Memo

To: Mayor Currin and Town Board of Commissioners
From: Meredith Gruber, Planning Director & Michael Elabarger, Senior Planner
Date: July 6, 2023
Re: 1216 Rolesville Road –
Map Amendment (Rezoning) Application MA 22-05
Voluntary Annexation Petition ANX 23-02

Rezoning Map Amendment MA 22-05

Annexation Petition ANX 23-02

Figure 1

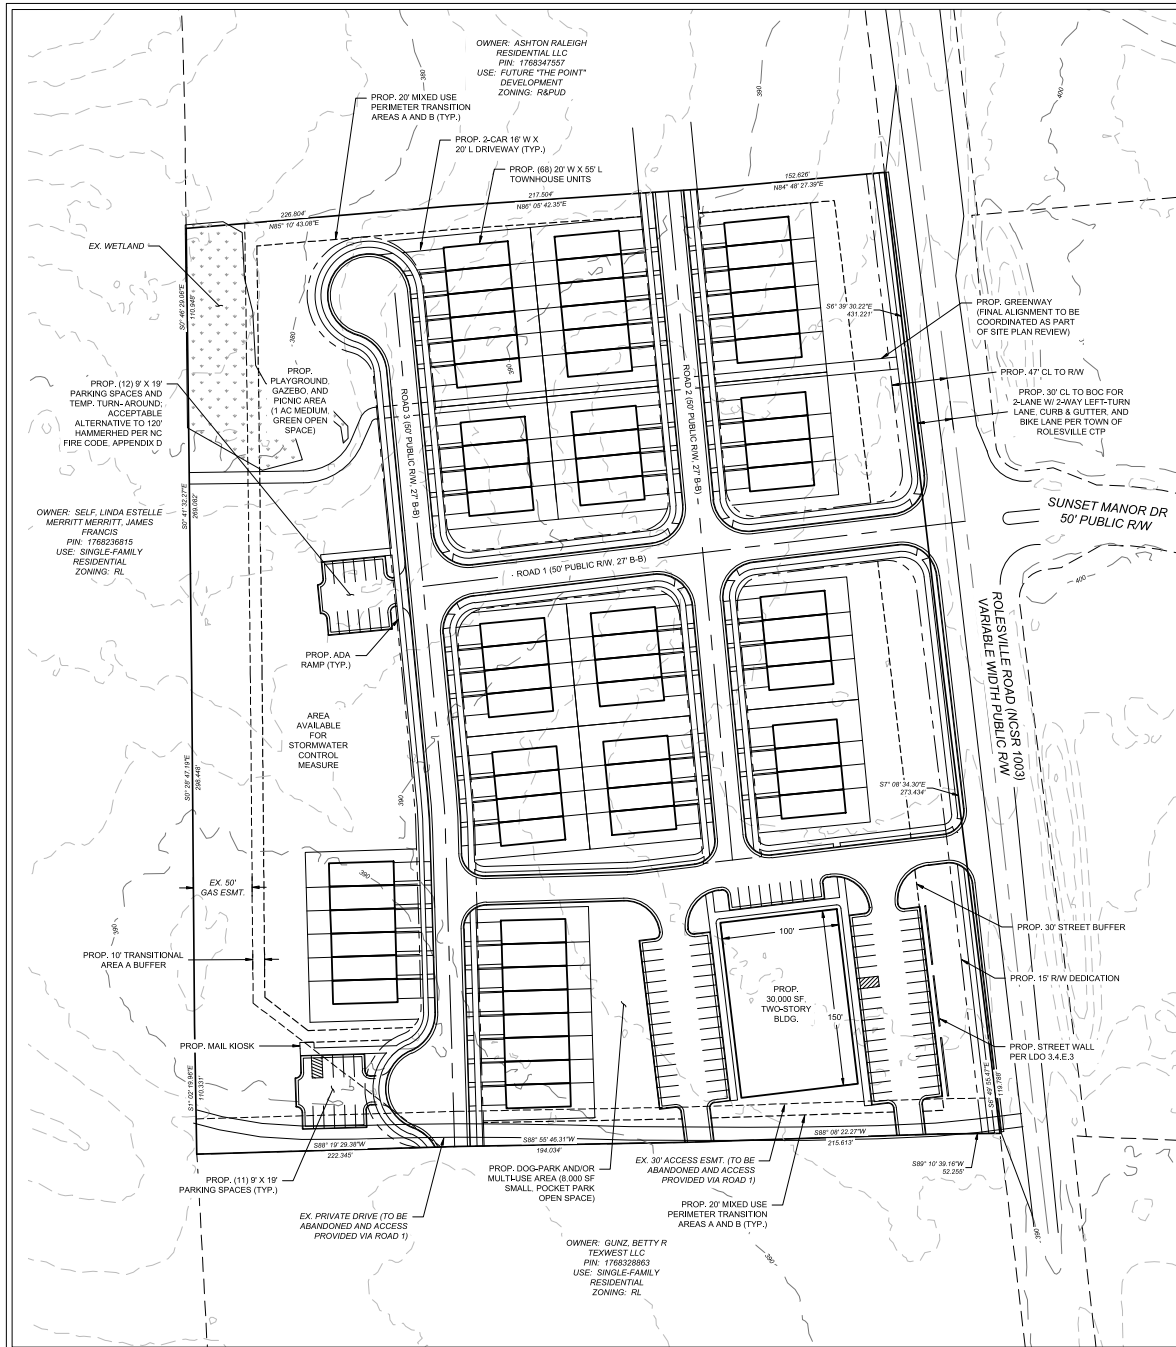
3.4.3.C. – Minimum Size	75% of the NC district land area (Maximum) may be residential use.	11.8 ac x .75 = 8.85 acres. Concept Site Plan assigns 10.54 acres to Uses not being “Commercial.”	Does not comply or Inconclusive – either exceeds the maximum or requires recalculation or revision.

3.4.3.D.1 – Mixture of Uses	15% of the NC district (minimum) for nonresidential uses*.	11.8 ac x .15 = 1.77 acres. Concept Site Plan assigns 1.26 acres to ‘Commercial use’	Does not comply or Inconclusive – either is short of the minimum or may require recalculation or revision.
There are many other NC District standards that cannot be determined for lack of specificity of Concept Site Plan, which is appropriate at this stage – these standards shall have compliance demonstrated at Subdivision, Site Development Plan, or Building Permit review.

Staff notes that the **Pre-Planning Board** design could be revised to demonstrate Compliance with LDO 3.4.3.C. and 3.4.3.D.1 much as the Applicant did on/for the **Post-Planning Board** version – the Applicant has simply not done that yet, so the compliance tables above should be viewed with that in mind.

Attachment 13 - Post-Planning Board Concept Site Plan

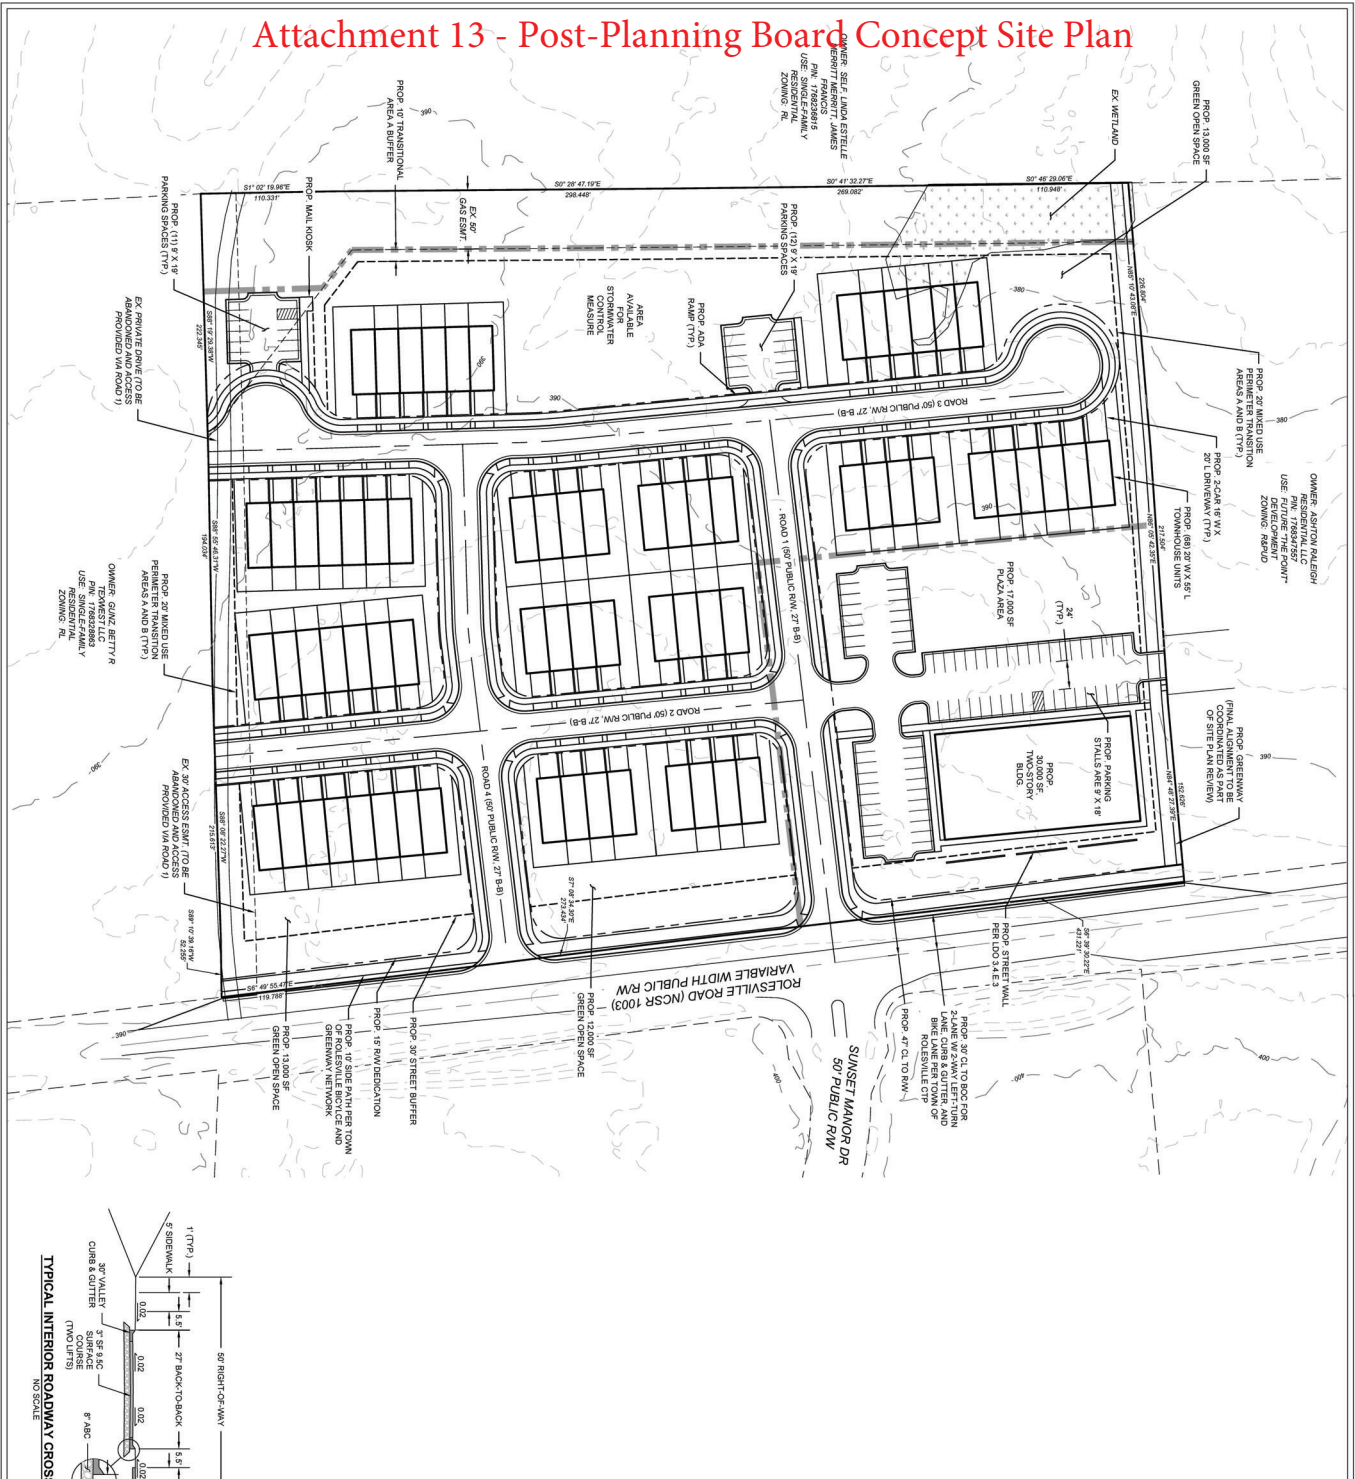
3.4.3.C. – Minimum Size	75% of the NC district land area (Maximum) may be residential use.	11.8 ac x .75 = 8.85 acres. Concept Site Plan assigns 8.46 acres (71.7%) to "Residential". *	Complies.*

3.4.3.D.1 – Mixture of Uses	15% of the NC district (minimum) for nonresidential uses*.	11.8 ac x .15 = 1.77 acres. Concept Site Plan assigns 2.35 acres (19.9%) to 'Commercial use'. *	Complies.*
There are many other NC District standards that cannot be determined for lack of specificity of Concept Site Plan, which is appropriate at this stage – these standards shall have compliance demonstrated at Subdivision, Site Development Plan, or Building Permit review.

Staff finds the **Pre-Planning Board** Concept Site Plan presents fewer potential design and development issues that may arise at the next stages of development (Preliminary Subdivision), compared to the **Post-Planning Board** version. Specifically, connecting a private nonresidential parking lot to a platted 50' public right-of-way is inconsistent with the LDO as a means of connecting to and continuing public streets. This is a design aspect that the Applicant may be able to overcome at the Preliminary Subdivision stage of development, but as presented, Staff does not support the direct connection of a parking lot to a platted street stub.

Staff supports the **Pre-Planning Board** concept site plan over the **Post-Planning Board** concept site plan, should the Town Board of Commissioners vote to approve the Rezoning request.
